SCONE AERODROME SAFETY INSPECTION

FEBRUARY 2016

AERODROME SAFETY INSPECTION

AIRPORTS PLUS PTY LTD

Photo 7 – Main taxiway

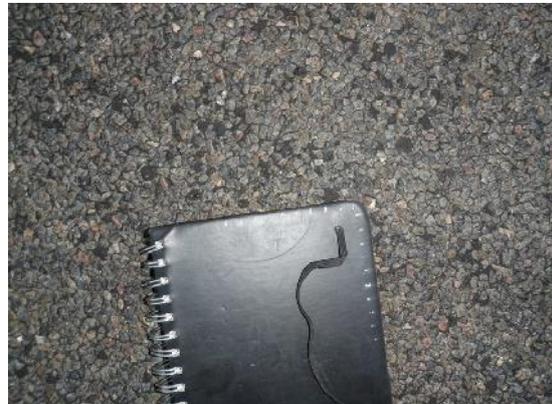
The main taxiway provides access to the apron area from runway 11/29. It is 15 m wide. It has a bitumen seal surface that appears to be of a similar age as the runway ends. It was basically sound with minimal stone loss and minor cracking.

The main taxiway should be resurfaced in about 5 years. It could be resurfaced with a bitumen seal containing at least 10 mm aggregate.
